CHANGE ORDER

Contract: Highway 90 Sinkhole Remediation

WORK CHANGE DIRECTIVE

Contract: Highway 90 Sinkhole Remediation

Untitled Map
Write a description for your map

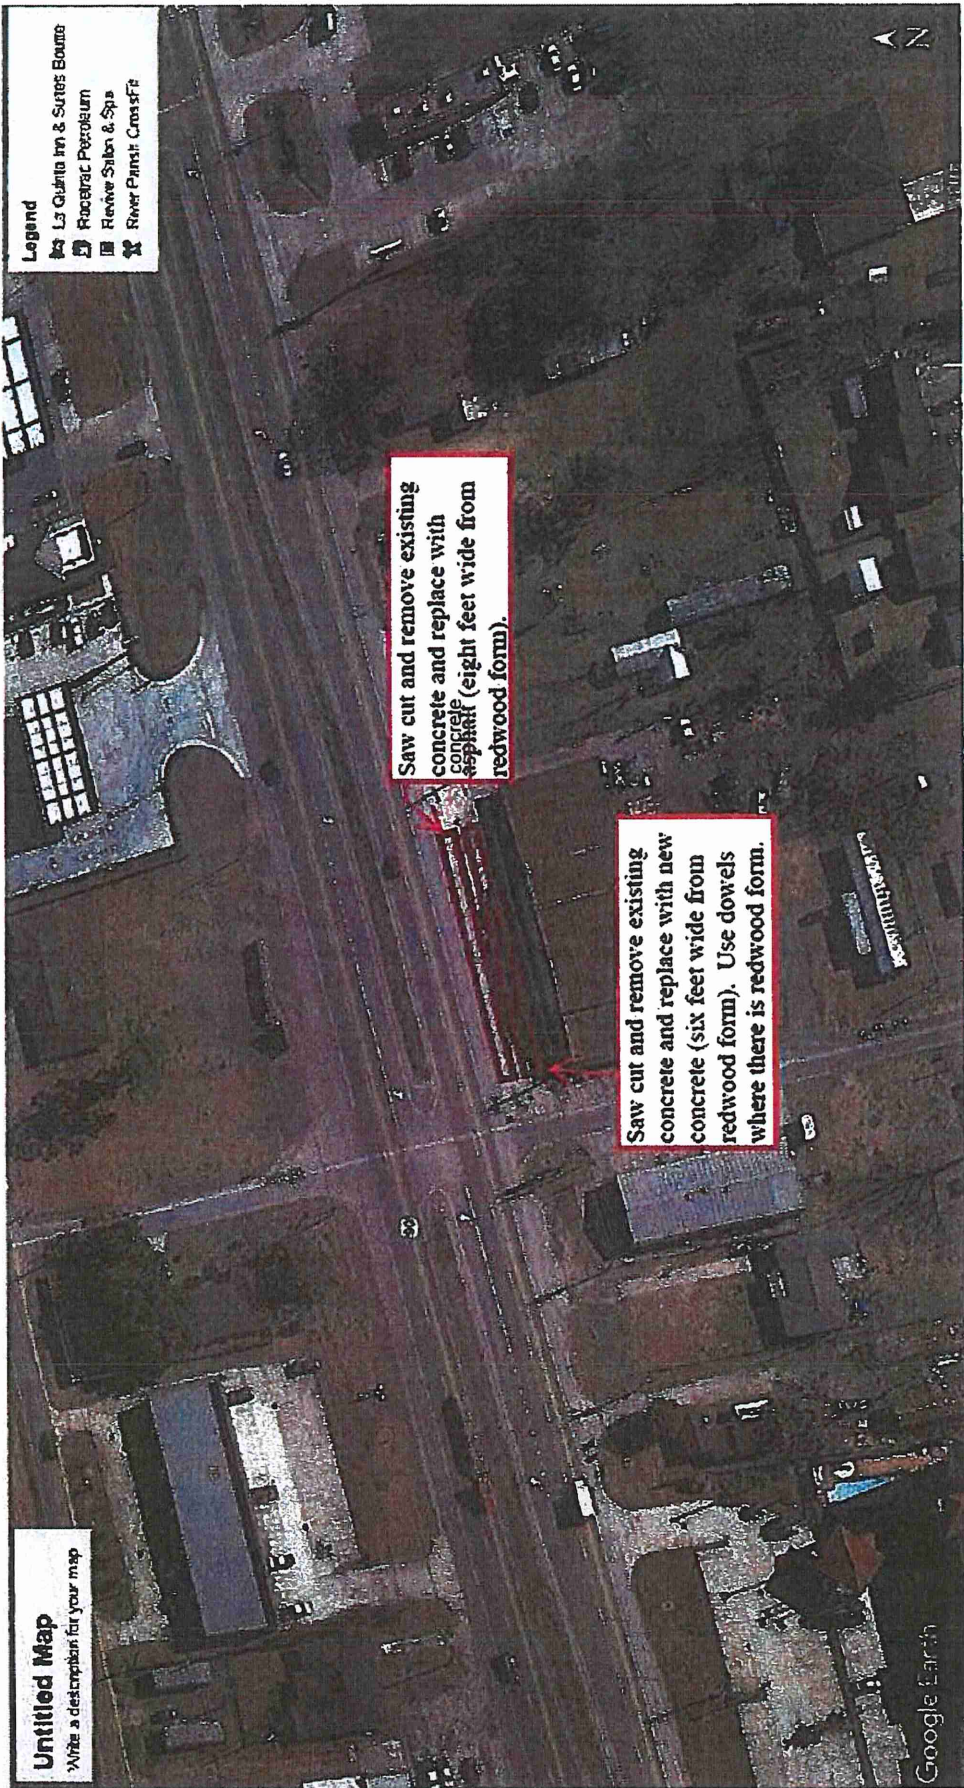
Description: Contractor is directed to remove and replace existing concrete pavement along project alignment at Sinkhole No. 2 location. Contractor to remove and replace a section of existing concrete pavement 6' wide x 200' long on North side of pipe trench and 8' wide x 200' long on South side of pipe trench. Contractor to saw cut concrete to provide a smooth transition between existing concrete and new proposed concrete. Adverse weather delays and days for additional work are included.

Saw cut and remove existing concrete and replace with concrete asphalt (eight feet wide from redwood form).

Saw cut and remove existing concrete and replace with new concrete (six feet wide from redwood form). Use dowels where there is redwood form.
